June 23, 2010

RE: NMED's "NOTICE OF DISAPPROVAL
RAILROAD RACK LAGOON OVERFLOW DITCH AND FAN-OUT AREA,
SWMU No. 8 SUBSURFACE INVESTIGATION FINAL REPORT
WESTERN REFINING COMPANY SOUTHWEST, INC., GALLUP REFINERY EPA
ID # NMD000333211
HWB-WRG-10-002"

**RE: NOTICE OF DISAPPROVAL
RAILROAD RACK LAGOON OVERFLOW DITCH AND FAN-OUT AREA,
SWMU No. 8 SUBSURFACE INVESTIGATION FINAL REPORT
WESTERN REFINING COMPANY SOUTHWEST, INC., GALLUP REFINERY
EPA ID # NMD000333211
HWB-WRG-10-002**

**RE: DIRECTION FOR ADDITIONAL
SOIL CONFIRMATION SAMPLE COLLECTION AND
APPROVAL OF EXTENSION REQUEST
RAILROAD RACK LAGOON OVERFLOW DITCH AND FAN-OUT AREA,
SWMU No. 8 SUBSURFACE INVESTIGATION FINAL REPORT
WESTERN REFINING COMPANY SOUTHWEST, INC., GALLUP REFINERY
EPA ID # NMD000333211
HWB-WRG-10-002**

FIGURE 7
RAILROAD RACK LAGOON OVERFLOW DITCH
B-8 FINAL BASE AND SIDEWALL CONFIRMATION
SAMPLE DRO RESULTS
WESTERN REFINING
GALLUP REFINERY
GALLUP, NEW MEXICO

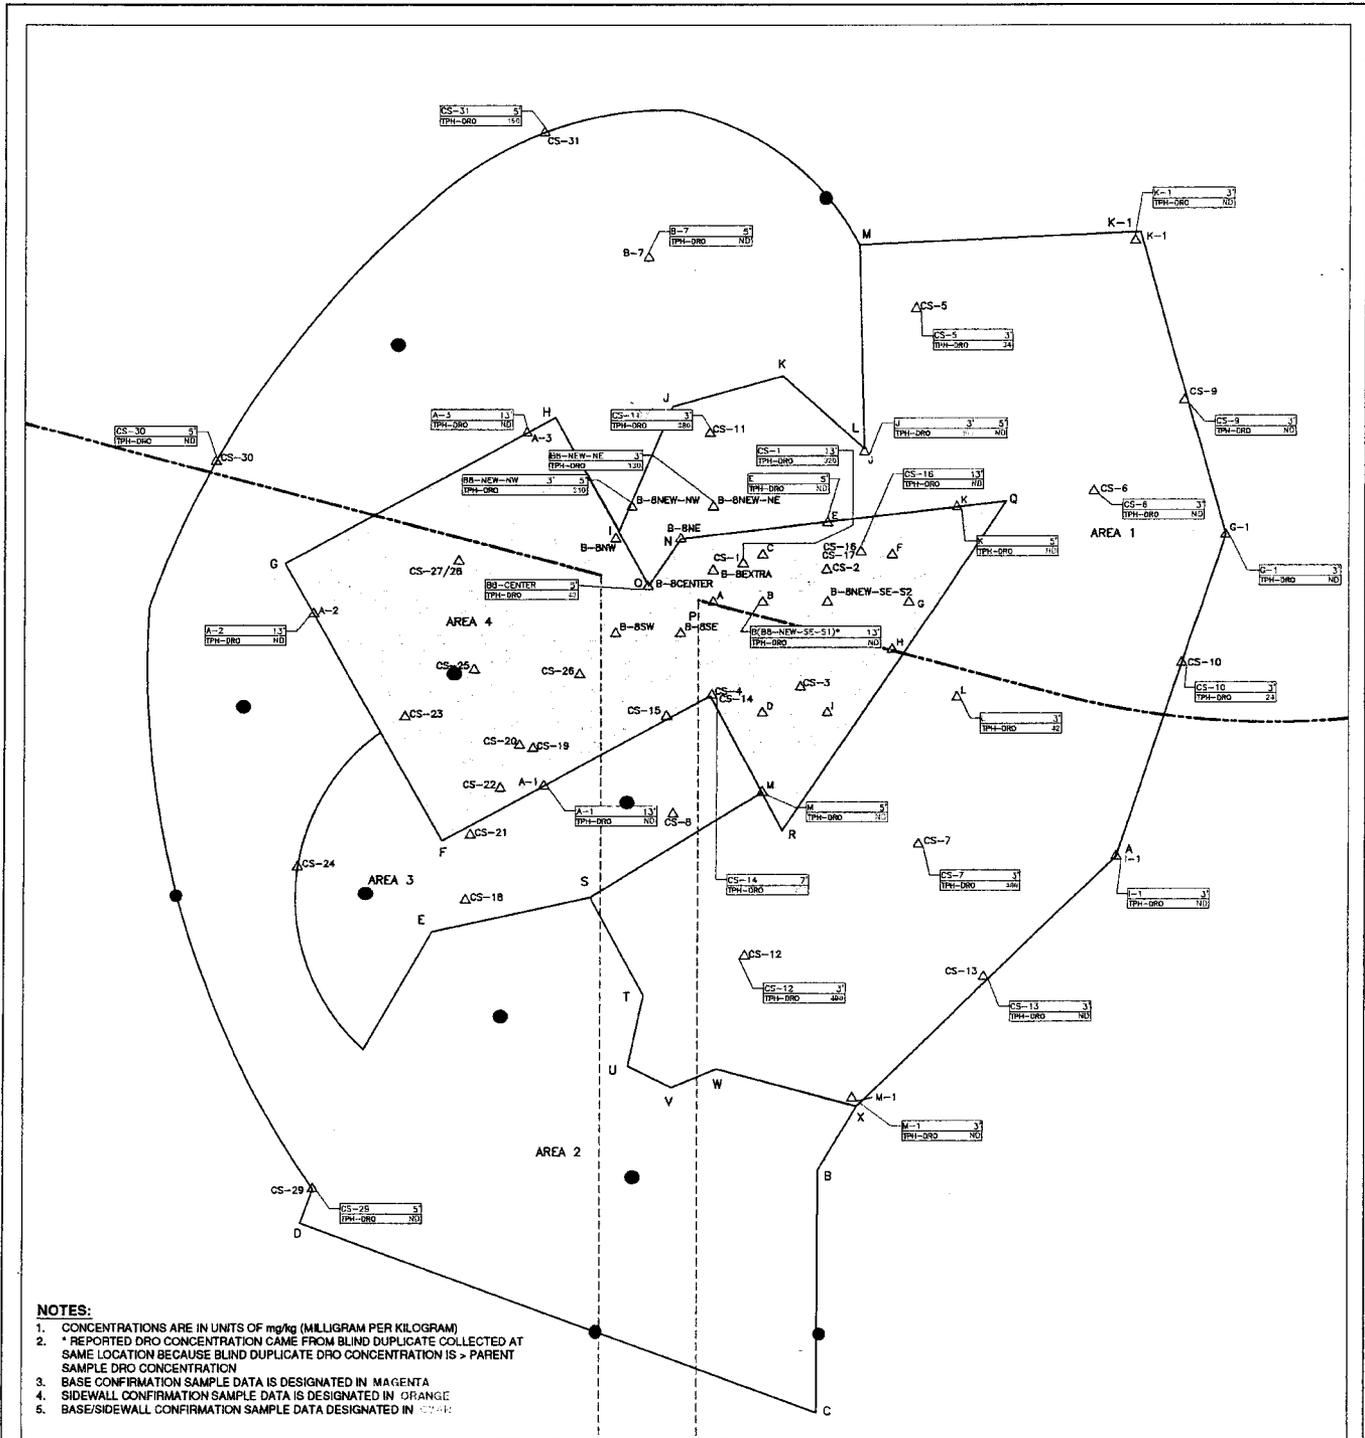
In order to determine whether or not the removal of all soils containing concentrations of DRO above 890 mg/kg from the fan-out area was completed, the Permittee needed to collect samples from the base and sidewalls of the excavation. Therefore, confirmation samples must be collected at the excavation bottom and from the sidewalls using a systematic sampling pattern and samples must also be collected from areas of visible staining, elevated moisture levels, and contaminated zones identified by field-screening and beneath areas with detected residual contamination.

In the revised Report, the Permittee must submit a figure depicting the locations of the final confirmation sample locations, depths the samples were taken, and the analytical results. The Permittee must submit proposed confirmation sample locations for NMED approval no less than 30 days before confirmation sampling activities begin.

NMED has amended Figure 7 to illustrate confirmation sample locations where the Permittee must collect confirmation samples. The Permittee must collect soil samples at the locations shown on Figure 7 as well as at any locations where field screening (visual, olfactory) indicates evidence of contamination. The additional confirmation sampling is limited in scope and only covers areas where confirmation samples have not been collected. The samples must be submitted to a laboratory for DRO analysis by EPA method 8015.

To help clarify this issue, Western has created Figure 7 to illustrate base and sidewall confirmation samples for each area. The sidewall samples are shown as orange and base samples are shown as magenta. There are a few samples that can be considered both base and sidewall samples. For example, CS-14 is collected at 7 ft bgs on the corner of Area 3 and Area 4. In respect to Area 3, this is a base sample. In respect to Area 4, it is a sidewall sample. These "base/sidewall" samples are illustrated on Figure 7 in cyan. Figure 7 is included as an attachment to this correspondence and, pending NMED approval, will be included in a revised version of the Report.

Figure 5 of the Report shows all sample locations, depths, and analytical results. Figure 7 and Table 2 (provided as attachments to this correspondence) have been created to show only the final confirmation sample locations. The revised Report will be updated to include Figure 7 and Table 2.

Note that Figure 7 and Table 2 only show confirmation sample results of those samples that were collected from the base or sidewall of the final excavation. Numerous other samples (for example, CS-24 and CS-18) were also necessary for delineating the DRO contaminated area. However, since these samples were not collected from the base or sidewall of the final excavation, they are not included on Figure 7 or Table 2. Figure 7 and Table 2 will be incorporated into the revised Report.

Due to the complexity of Figure 5, Figure 7 has been created for the B-8 Excavation to show only the final confirmation samples. The above mentioned orange and magenta color scheme is used to differentiate between base and sidewall samples. There are a few samples that can be considered both base and sidewall samples. For example, CS-14 is collected at 7 ft bgs on the corner of Area 3 and Area 4. In respect to Area 3, this is a base sample. In respect to Area 4, it is a sidewall sample. These “base/sidewall” samples are illustrated on Figure 7 in cyan.
